#	I support the Nor'West Arc Cycleway	I do not support the Nor'West Arc Cycleway	I generally support the Nor'West Arc Cycleway but have some concerns	No Response	
<b>Full Comments Nor' West Arc consultation submissions</b>					
1	Y				Meets a need for safer cycling down Middleton and Ilam Rd on my son's daily cycle [REDACTED]. Very happy to have cycles in our street too.
2			Y		I generally support the Now'West Arc with two main reservations 1) "The in-lane bus stop allows car parks along Ilam Road to be retained" Retaining on-road car parks is not a good enough reason for compromising this route's safety and usability. Putting bus stops in the bike lane will force cyclists to either move into the road to overtake the stopped bus, or wait behind the bus, breathing in diesel fumes- neither option a pleasant experience likely to encourage people to use the route 2) Smartlea Street, McBeath Avenue and Palmside Street are all described as quiet streets suitable for neighbourhood greenways but no mention is made of reducing speed limits. For greenways to work as part of an MCR, aimed at interested but concerned riders, speed limits on greenways must be reduced to 30km/hr. Speed bumps, bu

Sheet 25 of 31

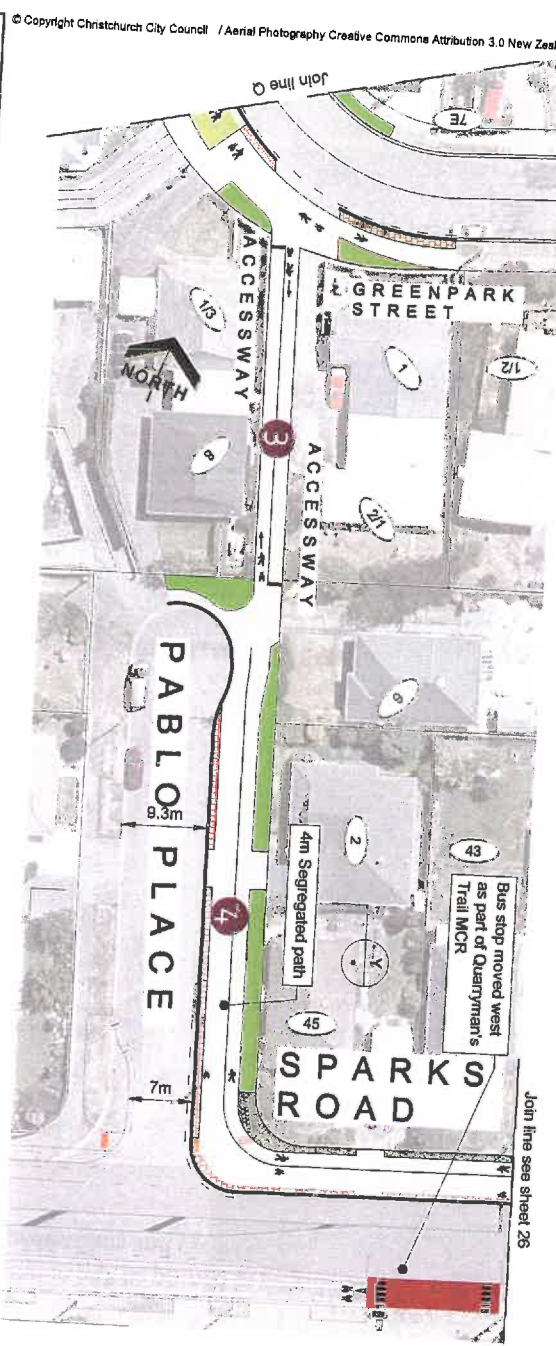
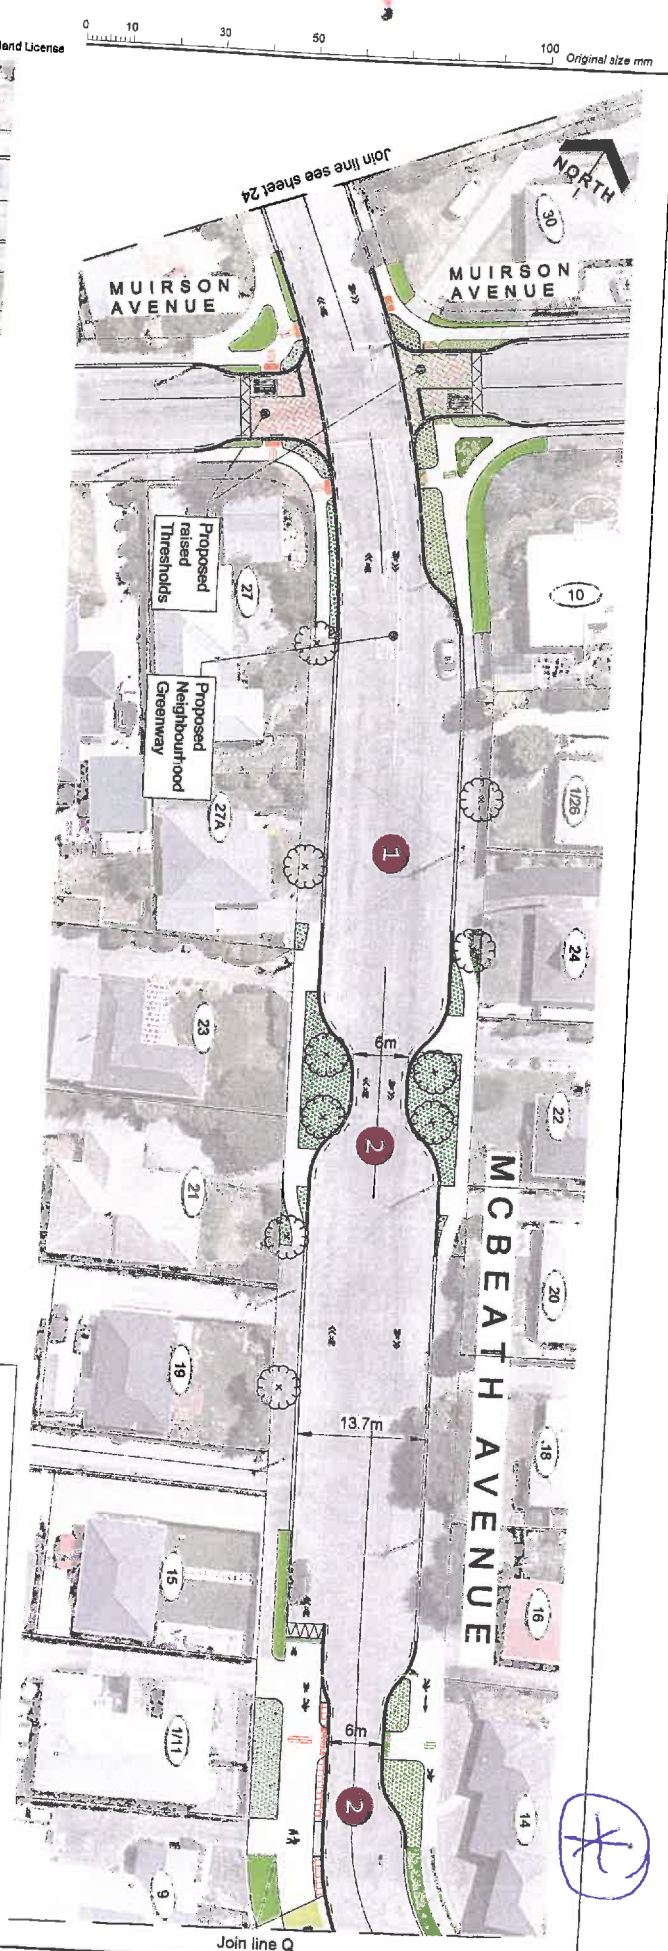
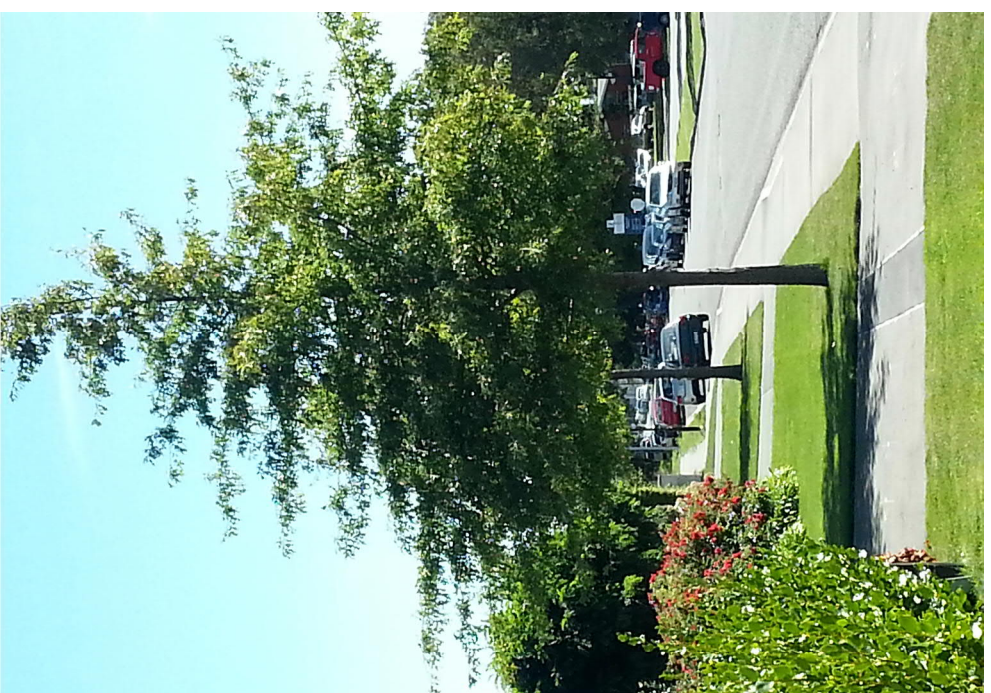
7	Y				
8	Y				As a home owner on Domain Terrace I think this is a fantastic idea, I fully support the Nor/west arc Cycleway along our street.
9	Y				1. Hi there is a vandalism issue on the existing fencing to Pablo Place to McBeath Ave linkway and wonder how that will be addressed. 2. Really support the tree planting and street works, though with the existing power lines, it would be nice to see these put underground at this opportunity. Is this going to happen? The plans don't show power poles in the smart glossy plans. 3. Wondering if more effort should be made on linking this to Lincoln Rd and then Hagley Park, as there is loads of bike traffic down Lincoln Road, but its very dangerous at peak traffic times. 4. I regularly bike to work down mcbeath ave, and the bridge widening on Smartlea Street is a really great idea, as the current one is a bit tricky to negotiate,

## SUBMISSION #40

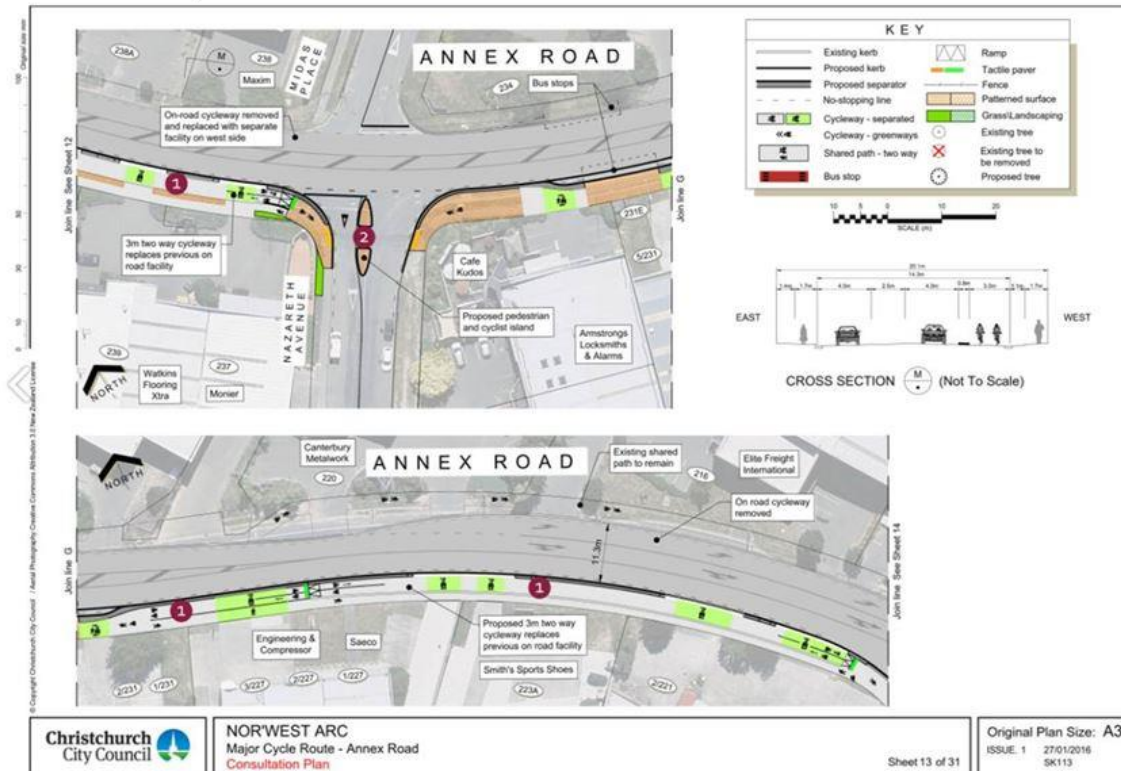
39	Y				
40			Y		<p>To whom it may concern,</p> <p>I have just learned today about the proposed changes to Nazareth Avenue in terms of an island being added for pedestrians and cyclists. I am a keen cyclist myself so I support the promotion of cycleways throughout the city I do however have some concerns on the proposal:</p> <ul style="list-style-type: none"> <li>• It appears that only the businesses on Annex Road were given information proactively i.e. someone visited. Unfortunately we are on a 'no exit' street that feeds onto Annex Road and will be impacted by the changes so I would have thought we would also have been proactively advised.</li> <li>• The proposed island on Nazareth Ave will be hazardous to trucks and also the cyclists/pedestrians seeking safety on it. In particular for heavy vehicles (container trucks, those with b-trains, long trailers) entering from Annex road onto Nazareth Ave. They require space to enter the street so that the tail does not climb the curb. Narrowing the space with an island will promote vehicles climbing the curb and the island.</li> <li>• It will create issues for traffic leaving Nazareth Ave onto Annex Road. Right now two vehicles can sit side by side – one turning left and one turning right. If it goes down to single lane it would back up the traffic significantly.</li> <li>• We operate a transport company down the street. I will provide a count in the next week of the amount of vehicles that enter that intersection based on our GPS. There are other logistics companies and commercial businesses that would be generating heavy vehicle traffic into the street.</li> </ul>

#	I support the Nor'West Arc Cycleway	I do not support the Nor'West Arc Cycleway	I generally support the Nor'West Arc Cycleway but have some concerns	No Response	
<b>Full Comments Nor' West Arc consultation submissions</b>					
40 <i>contd</i>					<p>Given I have only just learned of this I am not sure I can attend the meeting Thurs 16th of March. Are there other meetings available?</p> <p>The intersection I am referring to is below:  <i>Refer end of document for diagram</i></p>
41			Y		<p>Re: Sheet 2 - Homestead Lane to Kirkwood Ave</p> <p>Within a very small distance you have 2 T-intersections, plus a school, shops &amp; houses.</p> <p>The proposed 'separators' are death traps. Which further restrict movement in an area with this level of congestion (road users going into and out of Kirkwood Ave and Ramtree Street quite apart from we residents trying in vain to leave or access our homes).</p> <p>The existing cycle lanes are working well here - why on earth would you want to make things worse?</p>
